Date July 13, 2020

RESOLUTION HOLDING HEARING ON REQUEST FROM BROOK LANDING, LLC TO AMEND PUD CONCEPTUAL PLAN AND FOR APPROVAL OF PUD FINAL DEVELOPMENT PLAN FOR PROPERTY LOCATED IN THE 3300 BLOCK OF EAST 56TH STREET AND AT 5510 BROOK VIEW AVENUE

STAFF REPORT TO THE PLANNING COMMISSION

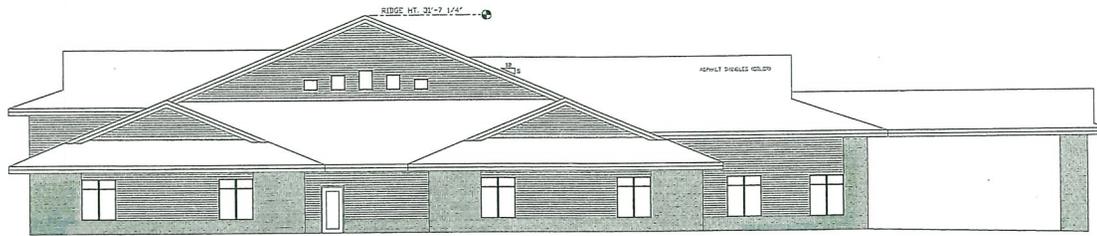
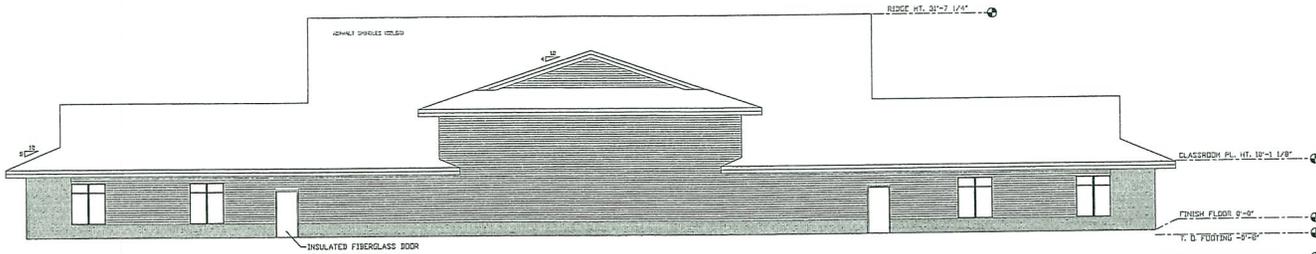
- 1) Inclusion of the building elevations submitted with the Site Plan (10-2020-7.110) as “Sheet 4” of the PUD Conceptual Plan, with the following modifications:

- b) Provision of a note that states each façade shall have a minimum transparency (windows and doors) of 12% of the façade.
 - c) Provision of a note that states the roof shall either be architectural asphalt shingles or standing seam metal.

Staff recommends that the building elevations submitted with the Site Plan (10-2020-7.110) should be included on the “PUD” Conceptual Plan as “Sheet 4” in order to provide an architectural character example of what can be developed on “Parcel B”.

Staff also recommends that notes be added to the elevations to state that each façade shall have a minimum transparency (windows and doors) of 12% and that the roof shall either be architectural asphalt shingles or standing seam metal.

NORTH ELEVATION
SCALE 1/8" = 1'-0"

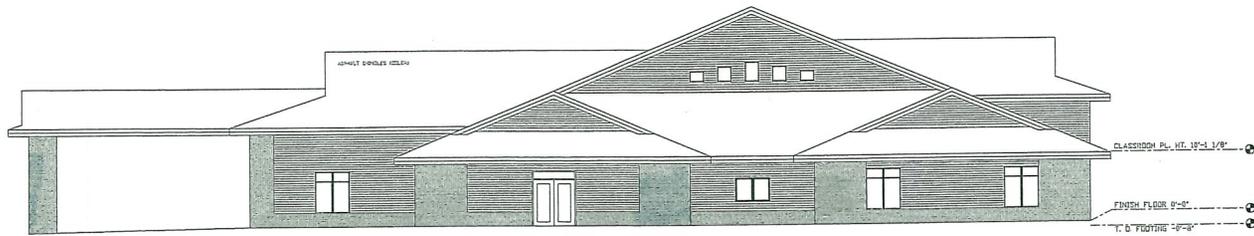
- a) Provision of additional brick on the “west façade” so that brick covers the entire first floor portion of the tall wall section at the middle of the building, including decorative soldier course at the top.
